UNITED STATES PATENT AND TRADEMARK OFFICE

APPLICATION NO.	FILING DATE	FIRST NAMED INVENTOR	ATTORNEY DOCKET NO.	CONFIRMATION NO.
10/708,381	02/27/2004	Xiangdong Chen	FIS920030367US1	2380

Office Action Summary

DETAILED ACTION

description: 30a, 30b, and 30c (see Fig. 5 with respect to paragraph 0025).

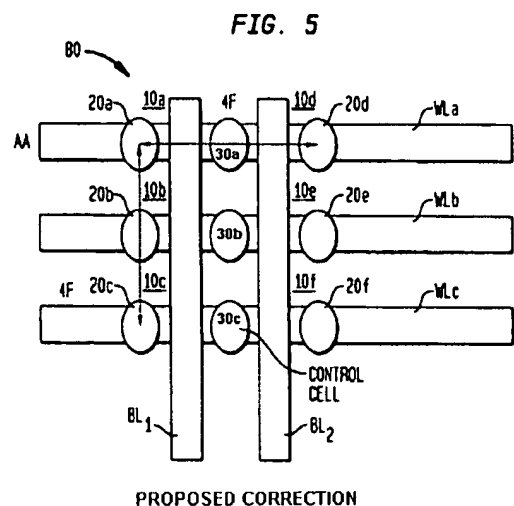
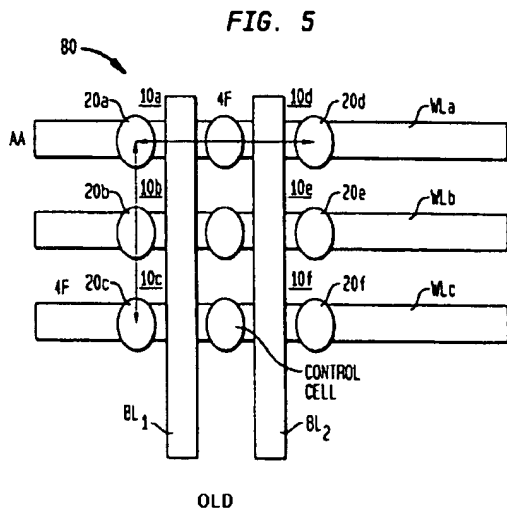
5. The drawings are objected to as failing to comply with 37 CFR 1.84(p)(5) because they do not include the following reference sign(s) mentioned in the

Examiner suggests adding 30a, 30b, and 30c to Figure 5 (see proposed correction below).
